**From:** Alan Wang  
**To:** Jared Wermiel  
**Date:** Fri, Jan 17, 2003 9:49 AM  
**Subject:** Re: 1/22 meeting on GE Revised Chapter 1 of CPPU Topical

New Chapter 1 for NEDC-33004P Rev 3.doc  
 2003 9:47 AM  
 MESSAGE

## 1.0 INTRODUCTION

Figure 1-1. Typical CPPU-Based Power Uprate Power/Flow Map

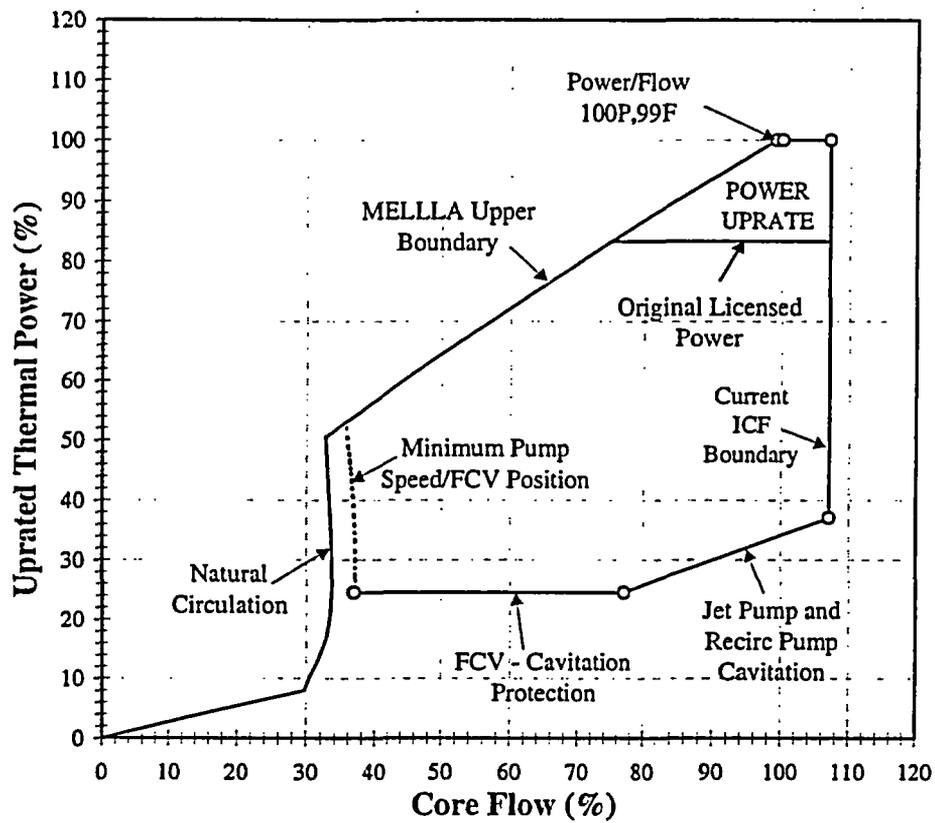
Comment: Page: 11  
 GE-6 JFH Opened Up Text Boxes
